ADDENDUM TO  
FUEL DENSIFICATION - INDIAN POINT NUCLEAR GENERATING  
STATION UNIT NO. 2

Revised 3-22-73

Addendum to "Fuel Densification - Indian Point Nuclear Generating Station Unit No. 2" (January, 1973)

FIGURE 3.10-1 CONTROL BANK INSERTION LIMITS  
FOR 4 LOOP OPERATION

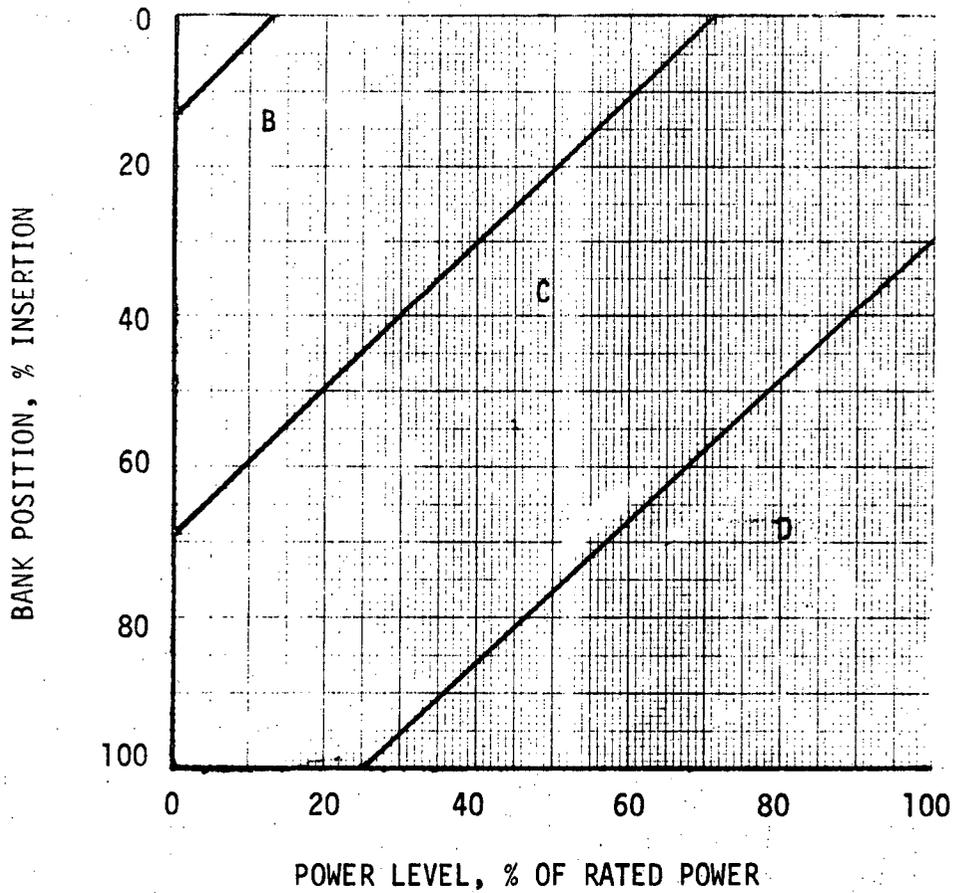
- a. The control rod insertion limits must be revised as indicated below in the revision for Section 7.0. This

Changes to the Technical Specifications are contained on the revised pages 7-2, 7-3, 7-4 and 7-6 and the revised Figures 3.10-1 and 3.10-2.

FIGURE 4.2 TOTAL HEAT FLUX PEAKING FACTOR -  $F_Q$  VS AXIAL OFFSET

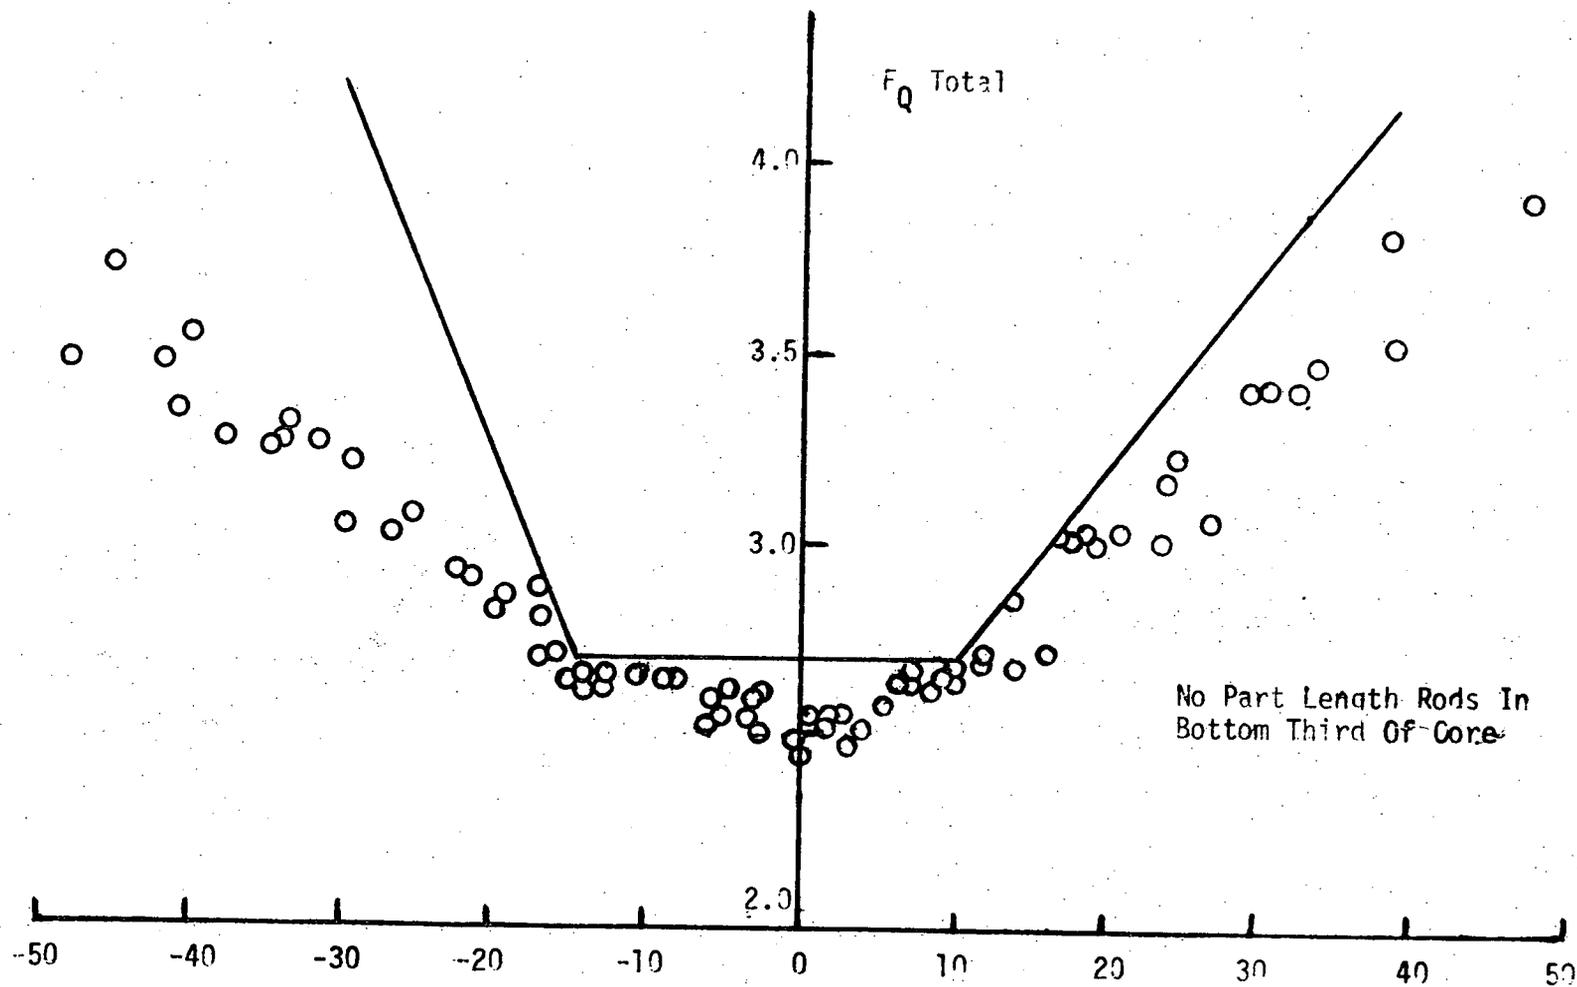
Since the issuance of the Indian Point Unit No. 2 Fuel Densification Report, the  $F_Q$  vs. axial offset correlation, which was presented in Figure 4.2, has been re-evaluated on a basis consistent with Attachment 3 of Westinghouse letter NS-SL-524 to D. Knuth from R. Salvatori, dated January 2, 1973. The methods employed for the results presented below are the same as in the original IPP 2 analysis, but with more control rod maneuvers and resultant transients considered. The same margins for uncertainty and manufacturing tolerances are included as in the previous analysis. As in the previous analysis, the axial power peaking factor and a horizontal peaking factor,  $F_{xy}$ , at the plane of the peak local power no lower than 1.44 were also incorporated. This new correlation is shown in the revised Figure 4.2 and necessitates the following changes in operating procedures to assure conformity to the assumptions of the revised analyses.

The re-evaluation indicates that a total peaking factor,  $F_Q$ , of 2.70 is still maintained by reference only to the ex-core detector axial offset.
